City of Palo Alto

Architectural Review Board ARB Staff Report

Summary Title: 1050 Page Mill Road - replacement office bldgs

Title: 1050 Page Mill Road (14PLN-00074): Request by 1050 Page Mill Road Property LLC for Architectural Review to allow demolition of two existing structures totaling 265,895 sf and for construction of four two-story office buildings totaling 265,895 square feet of floor area with below and at-grade parking and other site improvements. Zoning District: Research Park (RP). Environmental Assessment: An Initial Study and Draft Environmental Impact Report (EIR) has been prepared in accordance with the California Environmental Quality Act (CEQA).

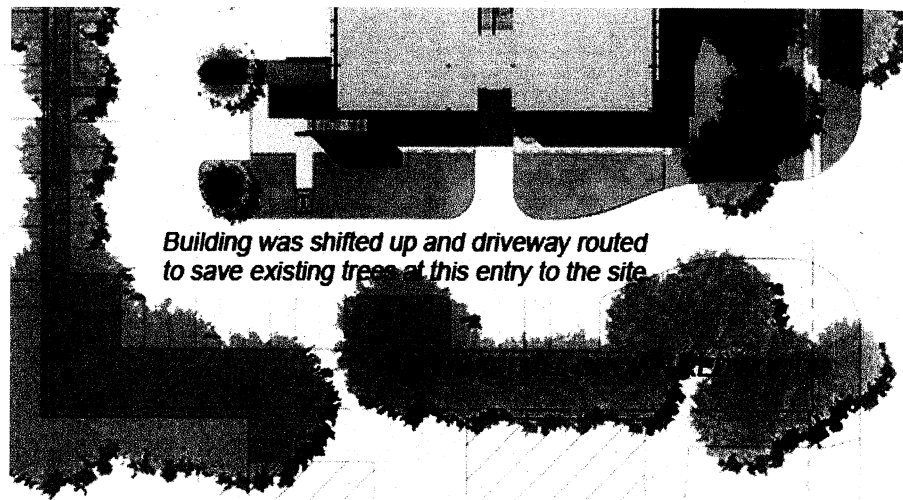
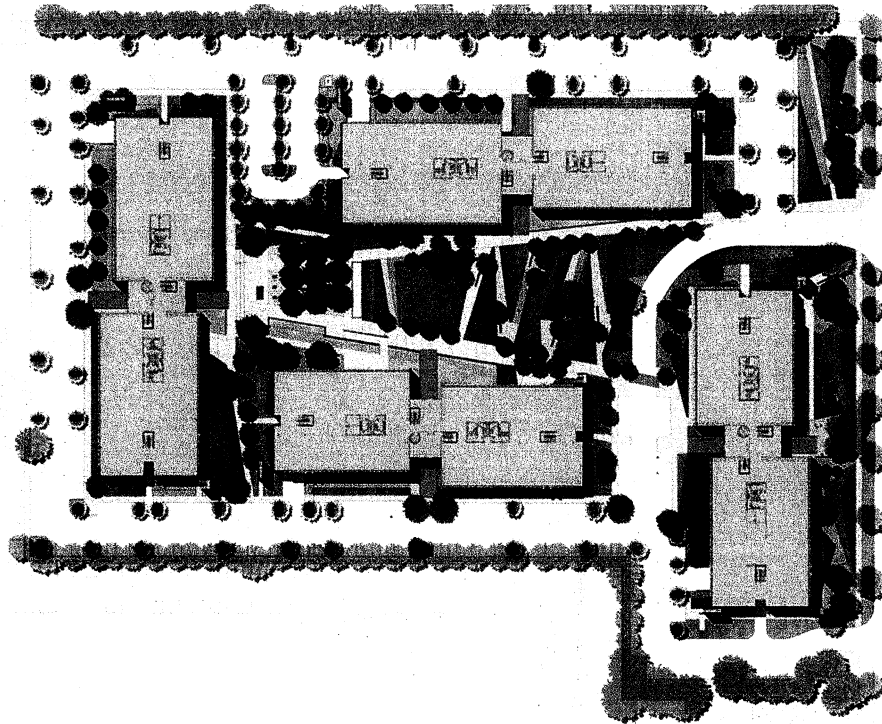
- a) Conceal surface parking with more landscape.
- b) Create smaller landscape "rooms" for more intimate sized spaces in large site.
- c) Study the visitor experience and entry sequence.
- d) Study how to conceal cars as they queue after entering the site from Page Mill Road.

Our initial proposal located about half the parking on the surface, and half below grade. We have now parked a higher ratio of cars in the below grade structure: 539 to 348 with space for an additional 86 surface spaces land banked.

Circulation around the perimeter was also reworked in collaboration with the City arborist to avoid existing trees - especially at the secondary right in / right out driveway on Page Mill.

The end result is there is less surface parking, and what remains is better screened.

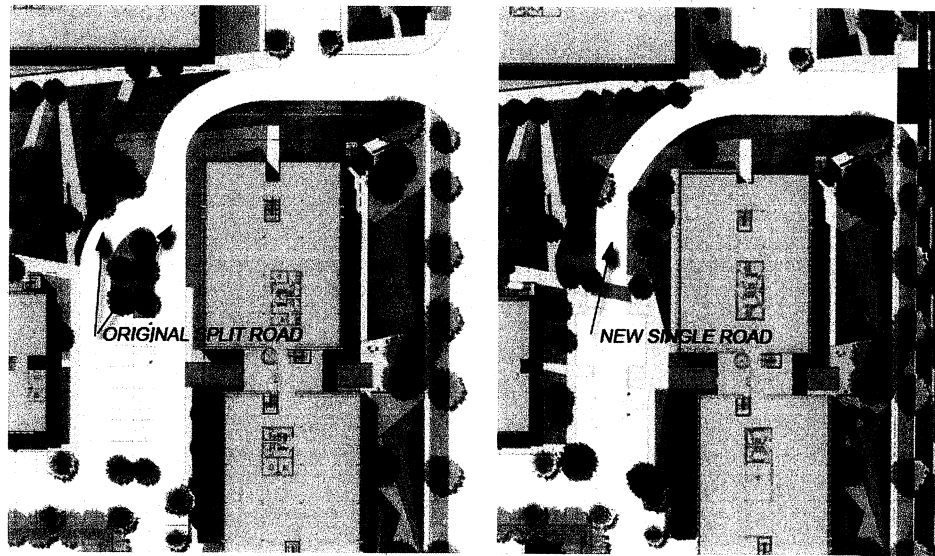
d) Study how to conceal cars as they queue after entering the site from Page Mill Road.

The loop road has been redesigned to better move cars quickly through the site. Originally we split the road creating a decision point as you enter with a double row of parking. Our traffic consultant suggested that the traffic moves more quickly with no decision point, and less parking.

This has the added benefit of more landscaping at this key point as well, and making for a safer pedestrian crossing from the central open space.

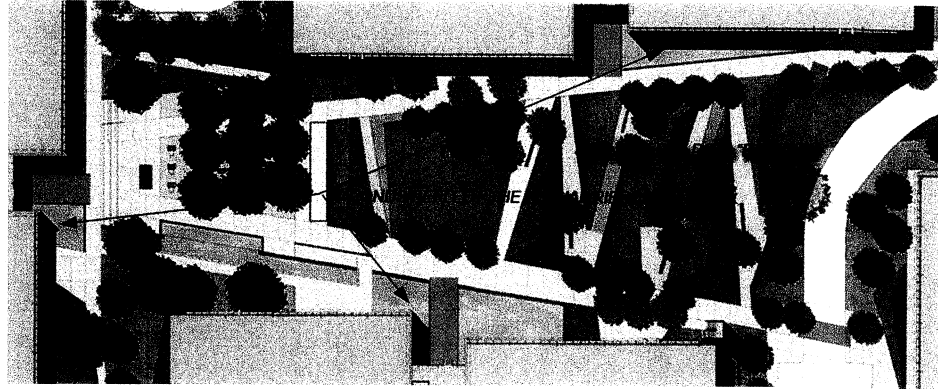
e) Explore ways to be even bolder with the curving aluminum ribbons and extend into the landscape.

There had been a suggestion that perhaps the aluminum ribbons on the building facades might break away and become more whimsical. We explored this, however became concerned that the character of the design changed from the goal of clean simplicity. The notion of pulling the building architecture into the landscaping was strong, however. Now it is the diagonal paths that slice through the site that become the landscape expression of the building's ribbons. Changing from our original curvilinear gardenesque landscape to this more stylized version of the California hills seem to keep the building and landscape in the same family.

In addition we are proposing ponds along the promenades to reflect the ribbons into the water at their most dynamic inflection points. This will provide an ever changing impression of the ribbons leaping off the buildings perhaps than a literal material move.

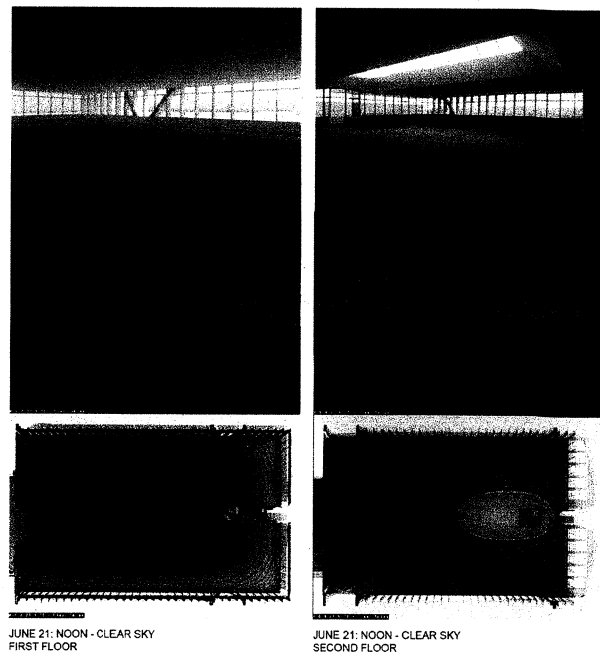
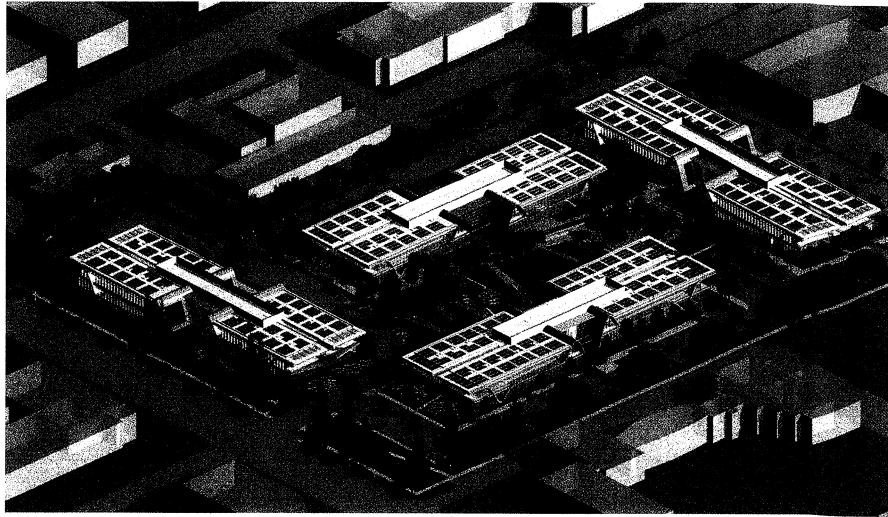
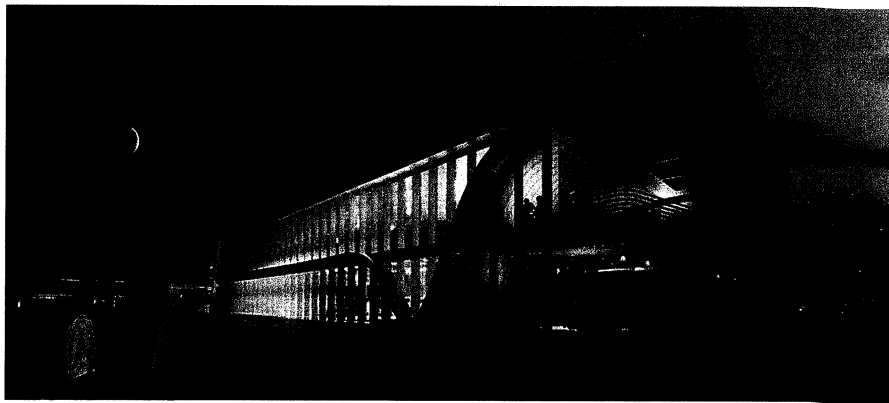
f) Address issues of sustainability, and also the potential sight of interior office clutter, in buildings that with predominantly glass skins.

Core goals of the project are to bring the outdoors in, and to be highly sustainable. This has become even more challenging with the adoption of more stringent T-24 guidelines. We remain on track with both goals, however. Following are some of the strategies:

- Careful daylighting studies, and the existence of even better LED lighting mean we can hold down the wattage necessary to light the building. Following is one of the hundreds of daylighting diagrams we have studied:

- We are providing complete PV arrays for the building roofs.

- Sun shading has become more refined and complete.

- One element addresses both sustainability, and addressing seeing visual clutter through clear glass. We will specify fritted glass for the lowest 30" of both floors. This is a tried and true approach for us to control the clutter of desks and boxes on the floors, and also allows us to insulate that zone where needed.
